## **Tam Design Review Board Final Notes Public Meeting – March 17, 2021**

- 2. Alta Way Grading Permit.** Daniel Chador of Alta Way Partners, Applicant, made introductory comments, noting that the originally proposed 10 lots included in the 2018 Initial Study have been reduced to 6 for the grading permit application (8 lots merged into 4). The revised Initial Study will lead to a Focused EIR, and will preclude a further extension of Alta Way, which will terminate in a hammerhead turnaround for fire vehicles. The larger lot sizes will allow for separation between the homes, and water pressure will be increased for fire flows. He said that a formal survey showing stakes at the lot corners would be conducted after the grading permit was granted. Mr. Chador invited direct contact from individual homeowners to discuss any issues.

The following is submitted as an analysis of the Alta Way Grading Permit application with regard to the policies, goals and objectives listed in the Tamalpais Area plan (Tam Plan). The analysis is broken into topics A through I. The analysis was completed by Andrea Montalbano, on behalf of the Tamalpais Area Design Review Board (TDRB). It was presented at th

# I) Google Streetview Images of area cited in Tam Plan as downslope lots between Loring and Erica

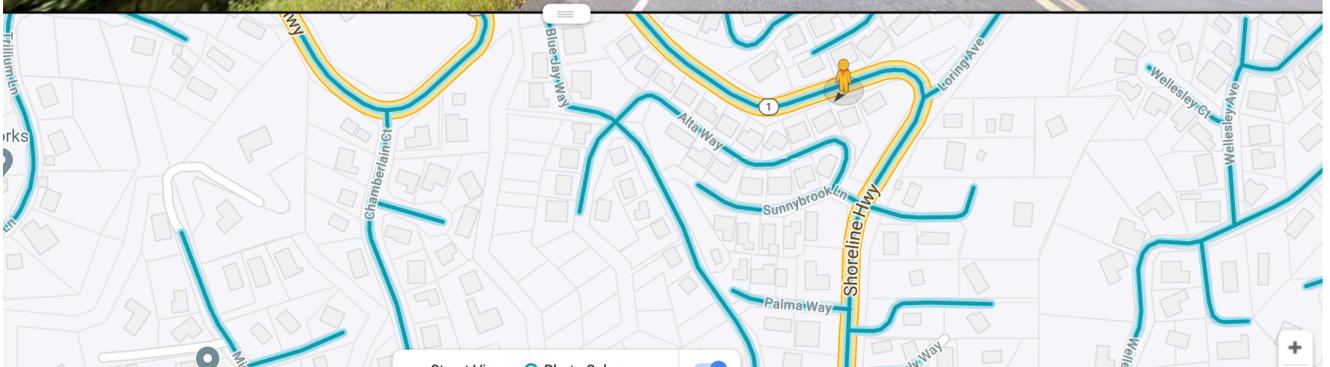
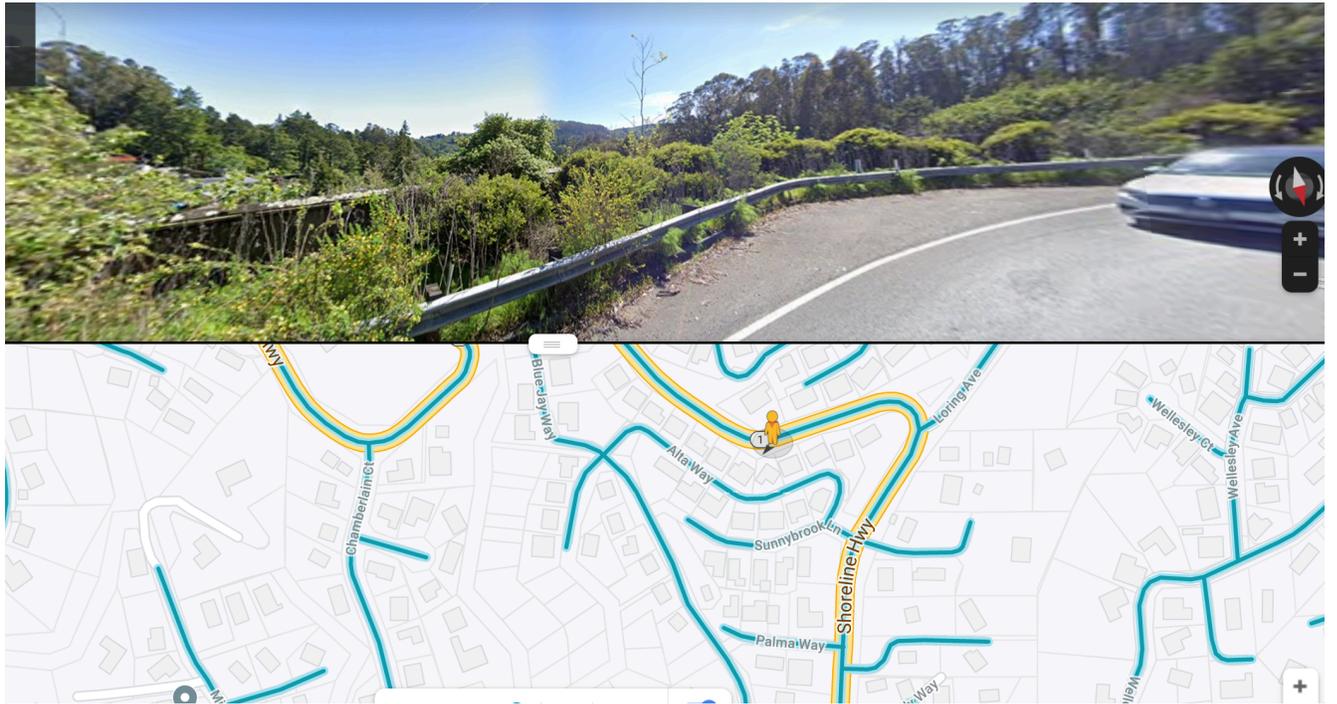
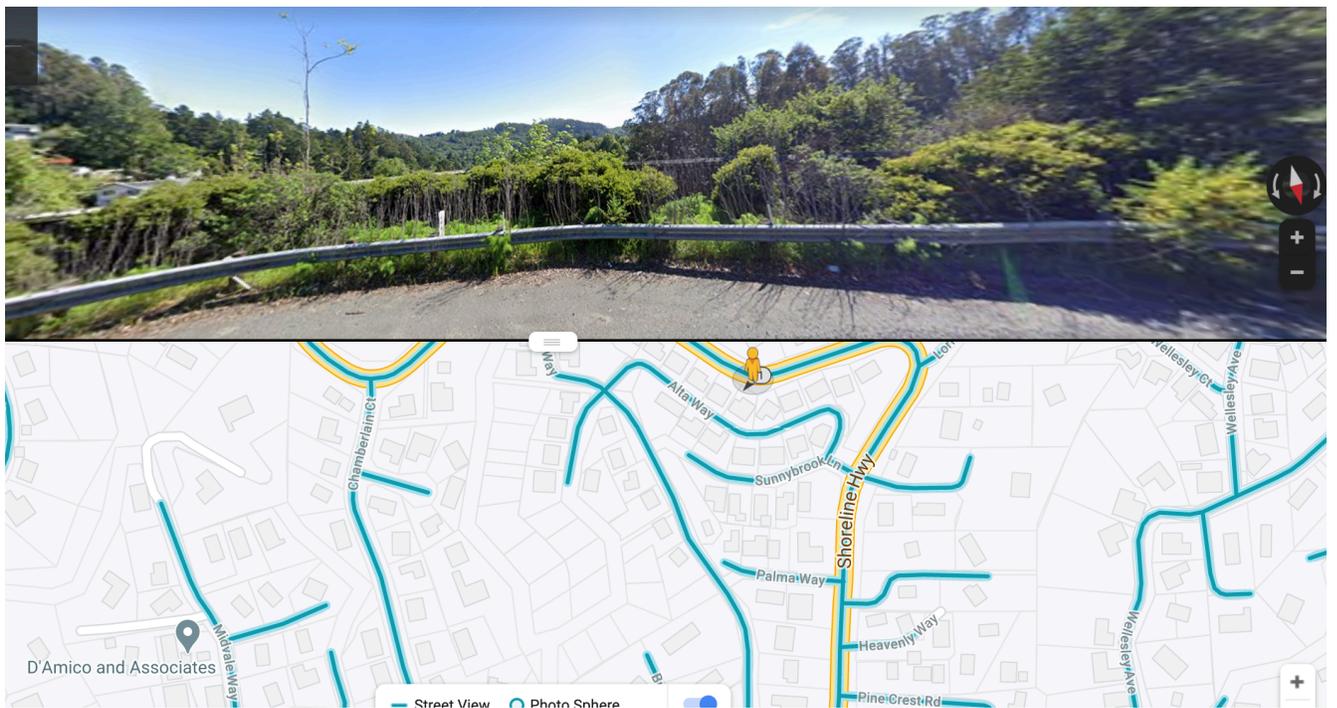
**TDRB Analysis:** The higher elevations of these lots form a visual backdrop for the lower portions of the neighborhood, and are specifically called out (with their mature, native trees) as important for open space value in the Tam plan. This was not mentioned or addressed in the Initial Study. The County should require an easement for the top of the lots, and allow clustered development at the bottom of the proposed road location as a tradeoff for development of the lots specifically cites as having open space value in the Tam plan.

Despite the Tam Plan being thirty years old, the need for the retention of the trees in this area remains unchanged. **See attached Google Street View images in Section I at the end of this document**, of the view from Shoreline Highway looking towards the site and Tam Valley beyond. The importance of these trees as a visual backdrop is clear.
